2024 Summary of Revisions

City of Bismarck Construction Specifications for Municipal Public Works Improvements

The City of Bismarck has revised the Construction Specifications for Municipal Public Works Improvements for 2024.

ISOMETRIC VIEW

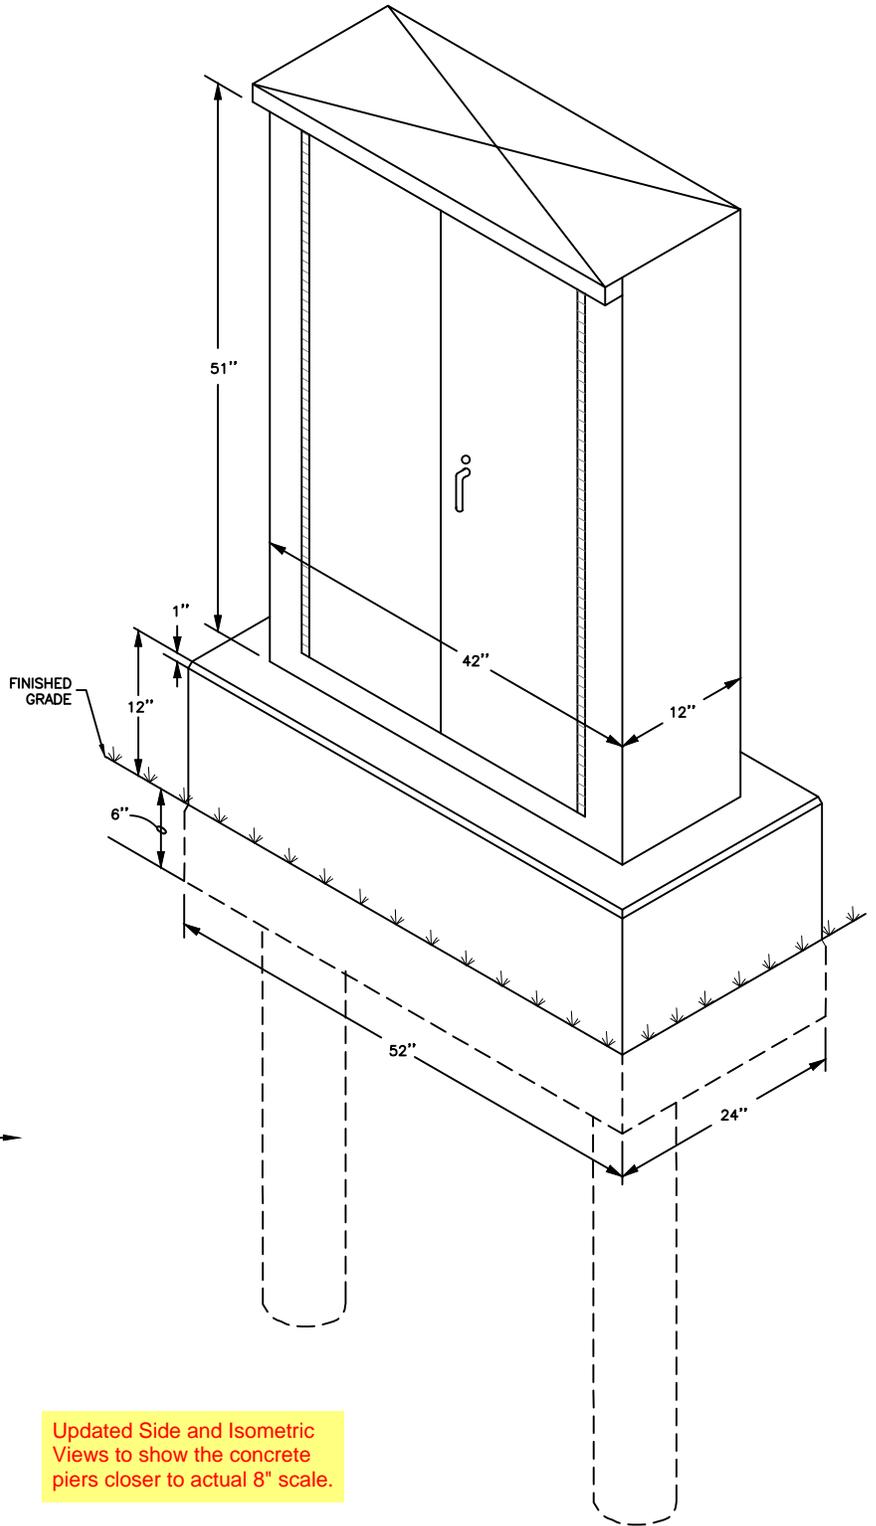
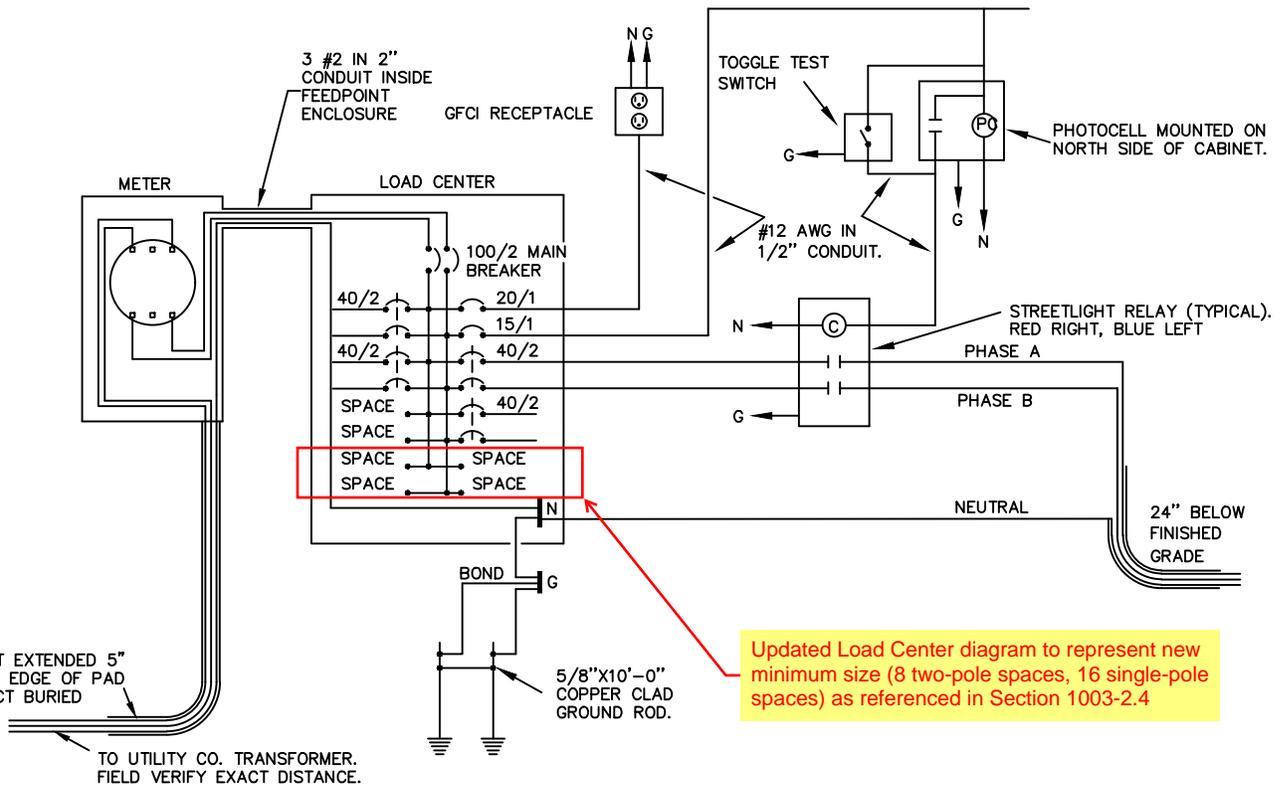
Updated Side and Isometric Views to show the concrete piers closer to actual 8" scale.
